AGENDA
CITY OF BENBROOK
PLANNING AND ZONING COMMISSION
THURSDAY, SEPTEMBER 8, 2016

S-16-02

Consider an extension of the Preliminary Plat of Benbrook Field Addition, being 46.27 acres of land in the H. Covington Survey Abstract Number 257 and the J. Stephens Survey, Abstract Number 1494 (west side of Benbrook Boulevard/U.S. Highway 377, north side of Mercedes Street, east of Walnut Creek, and south of I-20/Loop 820), P-10-01, as approved by the Planning and Commission on July 8, 2010.

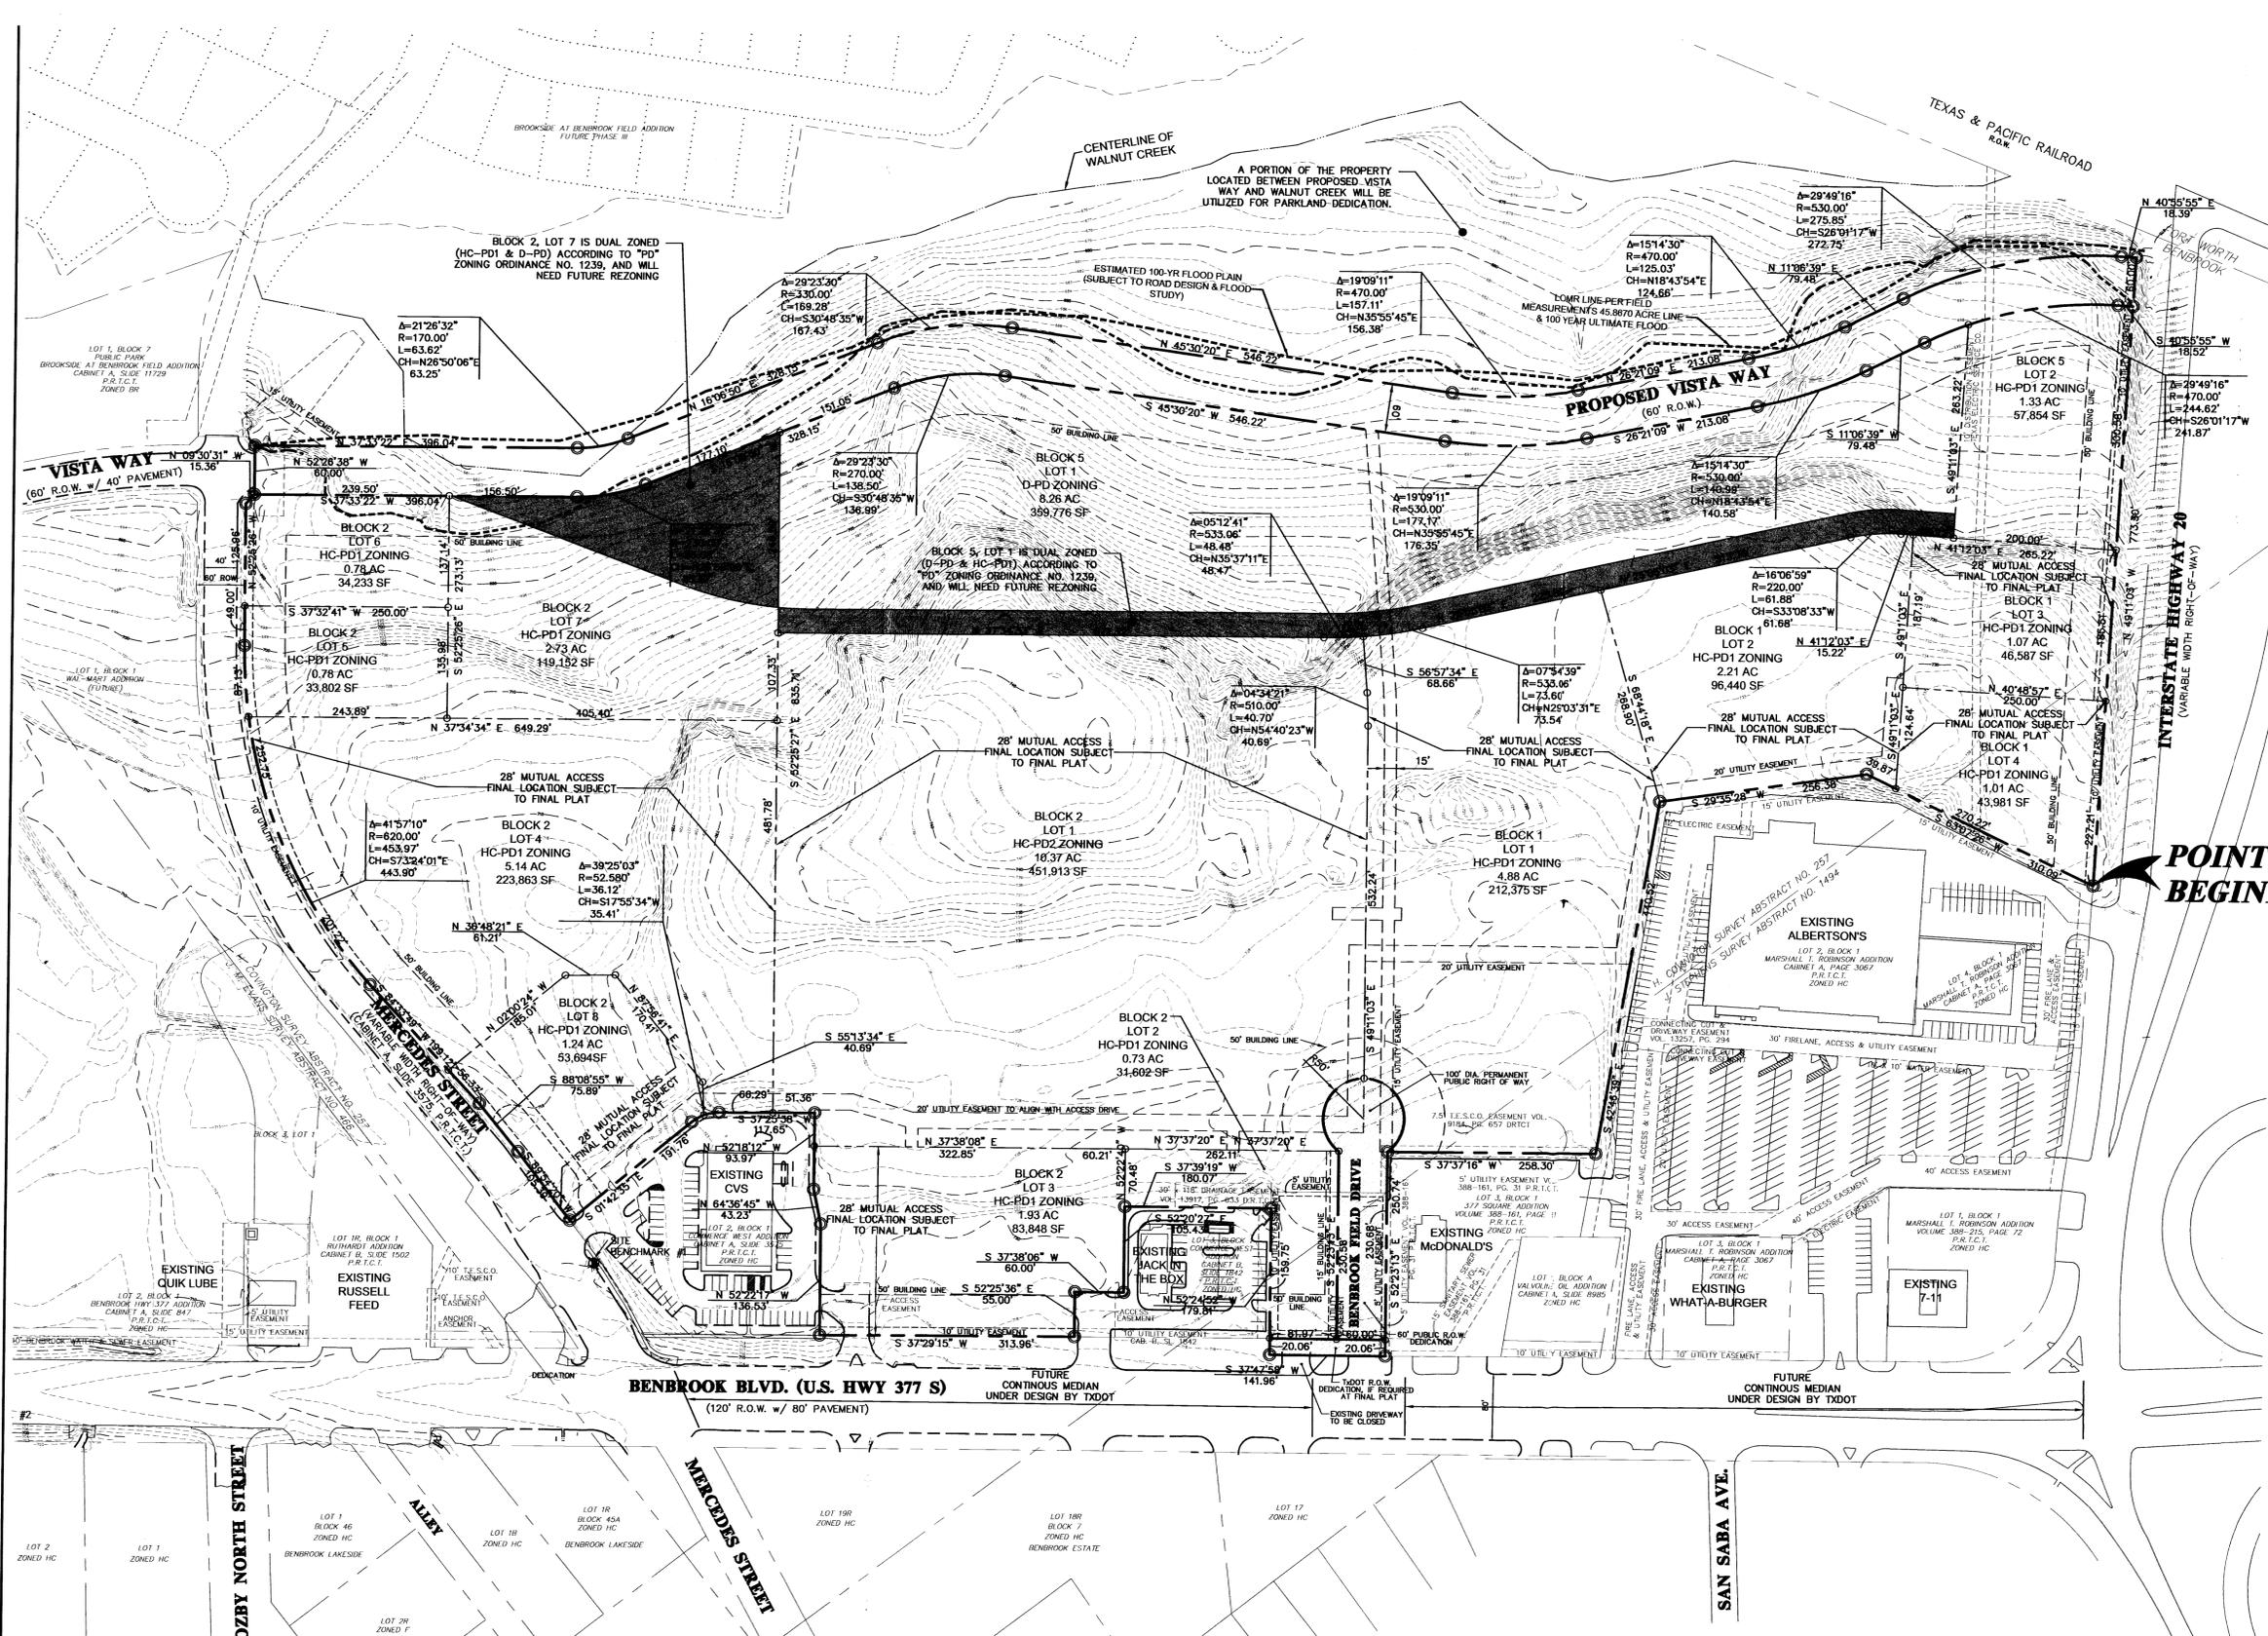
The City Planning Staff has reviewed the revised preliminary plat submittal and offers the following:

1. The P-10-01 preliminary plat is a revision of the P-07-02 preliminary plat considered by the Commission on July 12, 2007. The 2007 plat included the extension of Vista Way from Mercedes Street to the Loop 820 eastbound frontage road (in compliance with the Master Thoroughfare Plan, 7.3.4 of the Comprehensive Plan) and a new street, Benbrook Field Drive, connecting Benbrook Boulevard with the extension of Vista Way (in compliance with the 2004 Preliminary Plat approval for the overall project and 16.28.030, 2 Block lengths of the Subdivision Ordinance).

The configuration of the "D-PD" and "HC-PD" zoning district patterns was based on the location of Vista Way on the 2007 preliminary plat. With the revised location of Vista Way on the June 2010 preliminary plat, a 30-foot wide approximately one-acre strip on Lot 1, Block 5, will need to be rezoned from "HC"-PD" to "D-PD" and an approximately 0.8-acre portion of Lot 2, Block 7 will need to be rezoned from "D-PD" to "HC-PD" to have the zoning pattern conform with the P-10-01 lot pattern. The preliminary plat submittal incorrectly labels these areas as "dual zoned," when in fact they are split zoned. The rezoning adjustment is not part of the current preliminary plat consideration but should be accomplished prior to final plats of the affected lots.

3. The June 2010 preliminary plat differs from the 2007 plat in that the current plat proposes that lots "be final platted individually in no particular order", or scheduling. The revised plat does reference that "as each lot is developed, lot owner will provide utilities, drainage, and paving to and through lot as it is final platted".

4. The preliminary plat includes the proposed Benbrook Field Drive, with a 60-foot wide, 230-foot long public right-of-way dedication that includes a 100-foot Diameter Turnaround area. A 50-foot building line in a concentric configuration should be added around the turnaround portion of street right-of-way on Block 1, Lot 1 and Block 2, Lot 1.

Additional right-of-way dedication at the Benbrook Field Drive and Mercedes Street intersections (generally 20-foot by 20-foot pedestrian refuge areas) will be required to accommodate the enhanced intersection treatments proposed in the Benbrook Boulevard Master Plan.

1. Is the inlet in back of Jack-in-the-Box existing or proposed.
2. Is the intention to provide iSWM™ requirements for the entire plat or will each lot be required to provide their own?

1. I have concerns about access easement continuity.
2. Show section of access pavement. Will access be curbed?
3. 170-foot radius on Vista Way is too small.

1. As per discussions with Dunaway Associates on June 8, 2010, please add a 20-foot Utility Easement along the east side of Benbrook Field Drive to connect to the proposed Utility Easement north of the Jack-in-the-Box property.
2. Please change the note at the existing meter vault on the west end of the properties to: "Existing temporary meter station to be taken out of service." At the new meter vault location, please change the note to: "Install permanent meter station in existing meter vault."
3. On page 3 of 4, there is a fire hydrant within the turn-around at the end of Benbrook Field Drive. This needs to be moved outside of the turn-around radius.

1. Oncor Electric Distribution – Place 10-foot utility easement along the east side of Vista Way and around perimeter of Lot 1, Block 5.
2. Atmos Energy Gas – Response not received in time for this report.
3. Southwestern Bell Telephone – Preliminary Plat fully satisfies requirements of this office.
4. Charter Communications – Response not received in time for this report.

It is recommended that the Planning and Zoning Commission approve the Revised Preliminary Plat of Benbrook Field Addition, June 2010(P-10-01) subject to:

(PD Zoning Parcels 2-5 Combined)
 Being a 46.27 Acre Tract out of the H. Covington Survey, Abstract #257; and the J. Stephens Survey, Abstract #149.
 TOTAL ACREAGE = 42.46 ACRES
 (THIS PRELIMINARY PLAT REFLECTS THE MOTION TO APPROVE ON JULY 8TH, 2010 PLANNING & ZONING COMMISSION MEETING.)

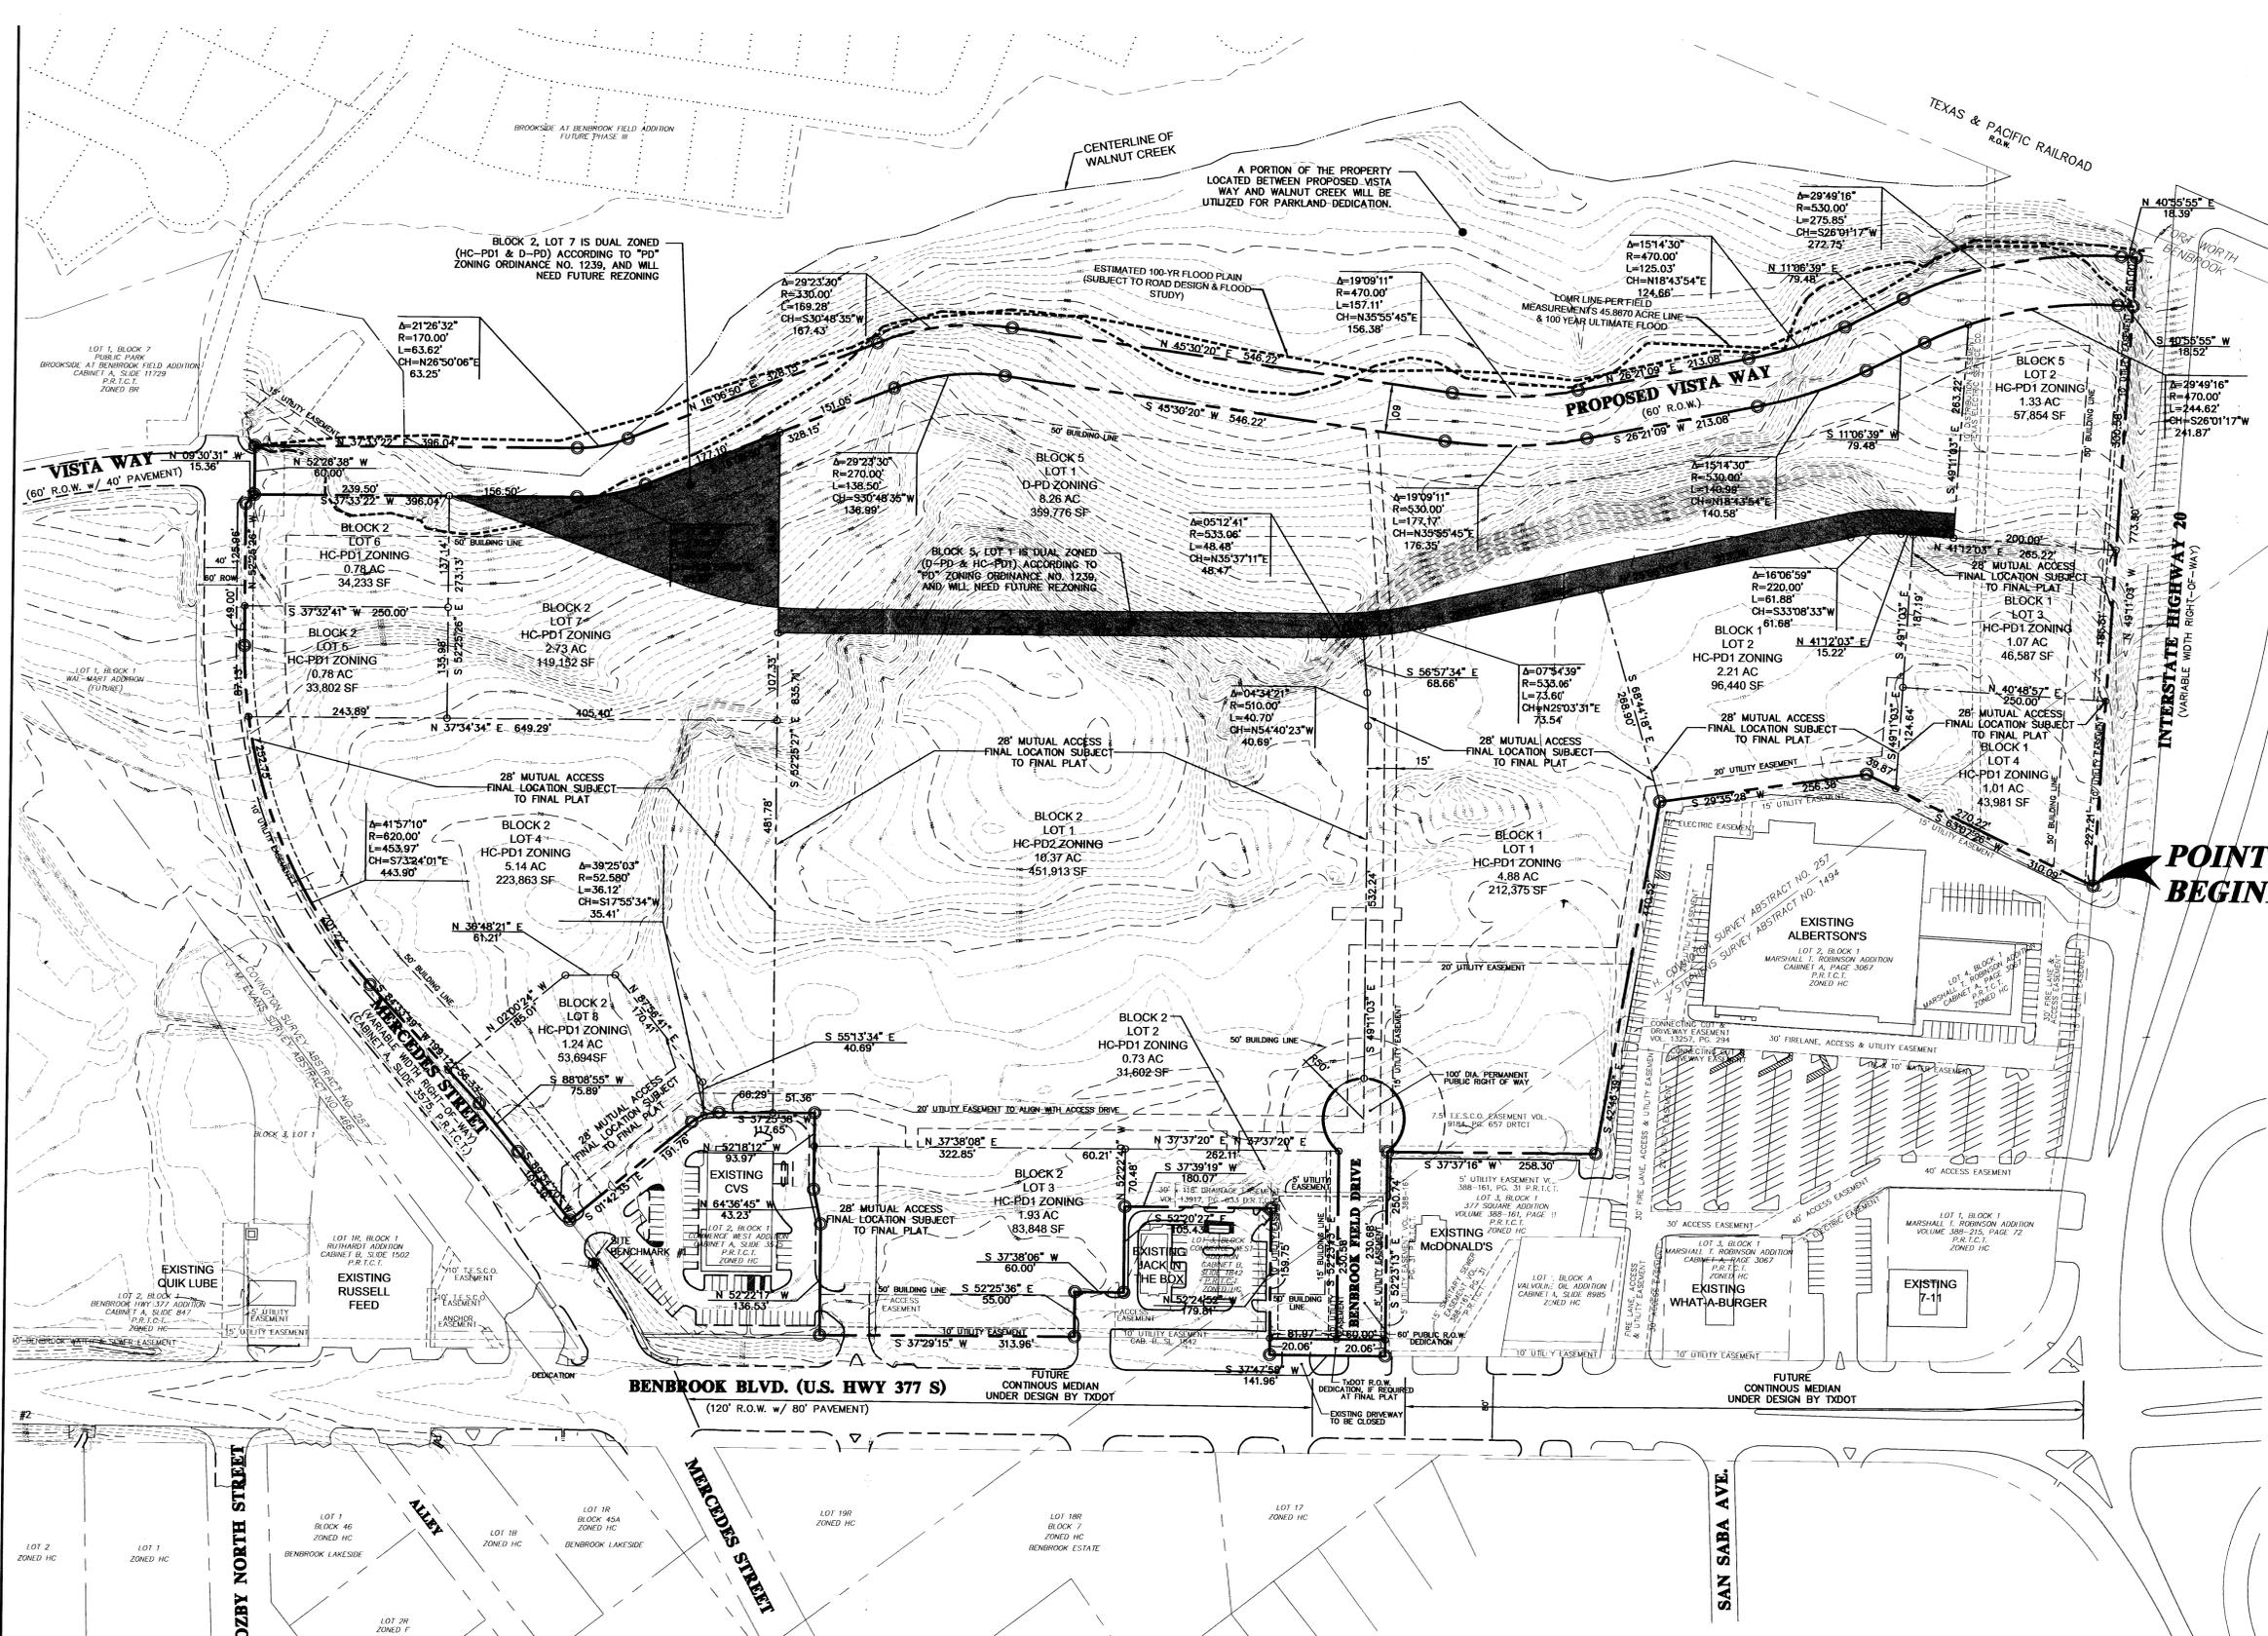
The City Planning Staff has reviewed the revised preliminary plat submittal and offers the following:

1. The P-10-01 preliminary plat is a revision of the P-07-02 preliminary plat considered by the Commission on July 12, 2007. The 2007 plat included the extension of Vista Way from Mercedes Street to the Loop 820 eastbound frontage road (in compliance with the Master Thoroughfare Plan, 7.3.4 of the Comprehensive Plan) and a new street, Benbrook Field Drive, connecting Benbrook Boulevard with the extension of Vista Way (in compliance with the 2004 Preliminary Plat approval for the overall project and 16.28.030, 2 Block lengths of the Subdivision Ordinance).

The configuration of the "D-PD" and "HC-PD" zoning district patterns was based on the location of Vista Way on the 2007 preliminary plat. With the revised location of Vista Way on the June 2010 preliminary plat, a 30-foot wide approximately one-acre strip on Lot 1, Block 5, will need to be rezoned from "HC-PD" to "D-PD" and an approximately 0.8-acre portion of Lot 2, Block 7 will need to be rezoned from "D-PD" to "HC-PD" to have the zoning pattern conform with the P-10-01 lot pattern. The preliminary plat submittal incorrectly labels these areas as "dual zoned," when in fact they are split zoned. The rezoning adjustment is not part of the current preliminary plat consideration but should be accomplished prior to final plats of the affected lots.

3. The June 2010 preliminary plat differs from the 2007 plat in that the current plat proposes that lots "be final platted individually in no particular order", or scheduling. The revised plat does reference that "as each lot is developed, lot owner will provide utilities, drainage, and paving to and through lot as it is final platted".

4. The preliminary plat includes the proposed Benbrook Field Drive, with a 60-foot wide, 230-foot long public right-of-way dedication that includes a 100-foot Diameter Turnaround area. A 50-foot building line in a concentric configuration should be added around the turnaround portion of street right-of-way on Block 1, Lot 1 and Block 2, Lot 1.

Additional right-of-way dedication at the Benbrook Field Drive and Mercedes Street intersections (generally 20-foot by 20-foot pedestrian refuge areas) will be required to accommodate the enhanced intersection treatments proposed in the Benbrook Boulevard Master Plan.

1. Is the inlet in back of Jack-in-the-Box existing or proposed.
2. Is the intention to provide iSWM™ requirements for the entire plat or will each lot be required to provide their own?

1. I have concerns about access easement continuity.
2. Show section of access pavement. Will access be curbed?
3. 170-foot radius on Vista Way is too small.

1. As per discussions with Dunaway Associates on June 8, 2010, please add a 20-foot Utility Easement along the east side of Benbrook Field Drive to connect to the proposed Utility Easement north of the Jack-in-the-Box property.
2. Please change the note at the existing meter vault on the west end of the properties to: "Existing temporary meter station to be taken out of service." At the new meter vault location, please change the note to: "Install permanent meter station in existing meter vault."
3. On page 3 of 4, there is a fire hydrant within the turn-around at the end of Benbrook Field Drive. This needs to be moved outside of the turn-around radius.

1. Oncor Electric Distribution – Place 10-foot utility easement along the east side of Vista Way and around perimeter of Lot 1, Block 5.
2. Atmos Energy Gas – Response not received in time for this report.
3. Southwestern Bell Telephone – Preliminary Plat fully satisfies requirements of this office.
4. Charter Communications – Response not received in time for this report.

It is recommended that the Planning and Zoning Commission approve the Revised Preliminary Plat of Benbrook Field Addition, June 2010(P-10-01) subject to:
